HISTORIC AND DESIGN REVIEW COMMISSION

August 18, 2021

HDRC CASE NO: 2021-377
ADDRESS: 1951 W HUISACHE AVE
LEGAL DESCRIPTION: NCB 1951 BLK 19 LOT 13
ZONING: R-6,H
CITY COUNCIL DIST.: 7
DISTRICT: Monticello Park Historic District
APPLICANT: David Buchanan/Better by Design
OWNER: Alex Hamilton/HAMILTON ALEX B
TYPE OF WORK: Side porch modifications and reconstruction
APPLICATION RECEIVED: July 28, 2021
60-DAY REVIEW: Not applicable due to City Council Emergency Orders
CASE MANAGER: Stephanie Phillips
REQUEST:

The applicant is requesting a Certificate of Appropriateness to replace an existing uncovered, concrete side porch with a new uncovered, wood side porch with decorative railings.

proposed porch design
for improved drainage
along east lot line

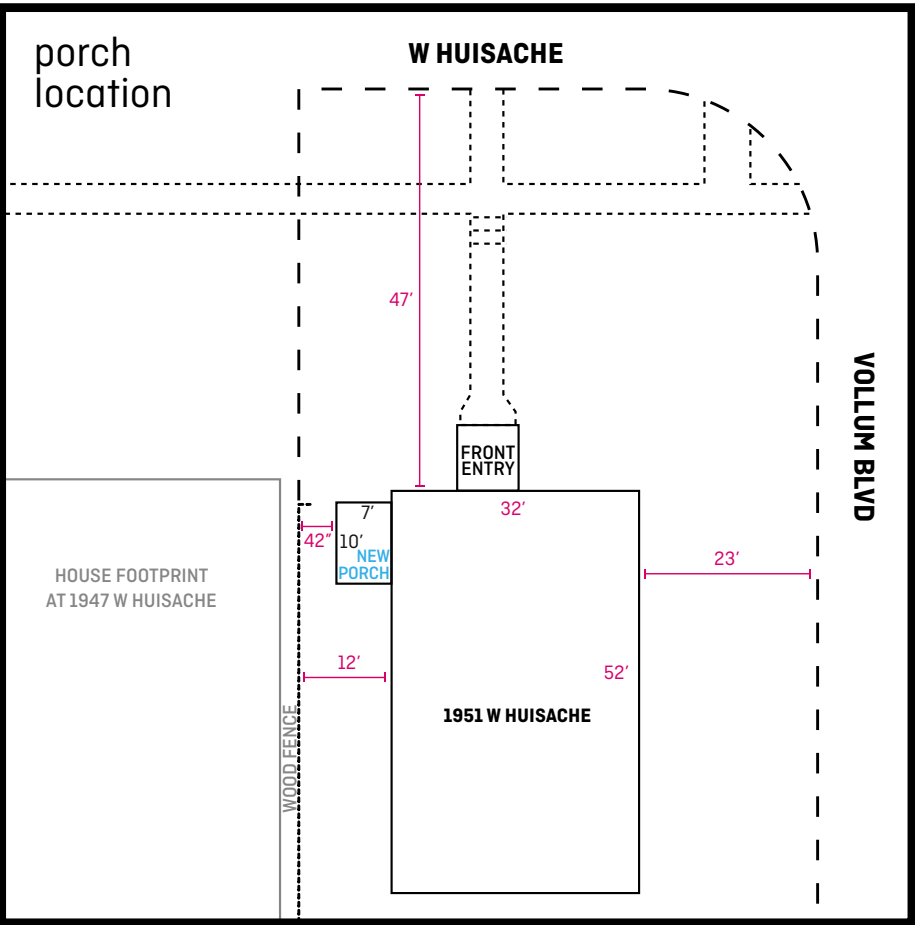
- b. **SIDE PORCH MODIFICATIONS** – The applicant has proposed to modify the existing side porch. The porch is located on the eastern elevation of the structure and is visible from the public right-of-way. The porch includes an elevated concrete slab, concrete steps clad with orange and yellow tiles, and a concrete railing featuring a thick, decorative design with rails in an ‘X’ design. Until recently, a large tree was growing at the base of the porch and caused structural damage. The applicant has cited substantial flooding issues created at the foundation in this area due to the buckling porch, which now slopes into the house. Per the 1911-1951 Sanborn Map, this side porch is not original and was a later addition to the home. The applicant has proposed to reconstruct a new porch in the same approximate location using a wood structure, wood decking, and a new decorative wood railing that takes inspiration from the existing railing but is visually and physically lighter. All foundation and drainage issues will be corrected

and properly directed towards the street. Per the Guidelines, alterations to side and rear porches should result in a space that functions, and is visually interpreted as, a porch. Design replacement elements, such as stairs and railings, to be simple so as to not distract from the historic character of the building. Significant foundation features such as decorative vents and grilles and lattice panels are replaced in-kind when deteriorated beyond repair. When in-kind replacement is not possible, use features matching in size, material, and design. Replacement skirting should consist of durable, proven materials, and should either match the existing siding or be applied to have minimal visual impact. Foundation draining elements, such as downspouts, should be directed away and soil should be sloped away from the foundation to avoid moisture collection near the foundation, which can cause deterioration. Based on the non-original nature of the existing porch and the compatible and subordinate design of the proposed replacement porch, staff finds the request appropriate.

Staff recommends approval based on findings a and b.
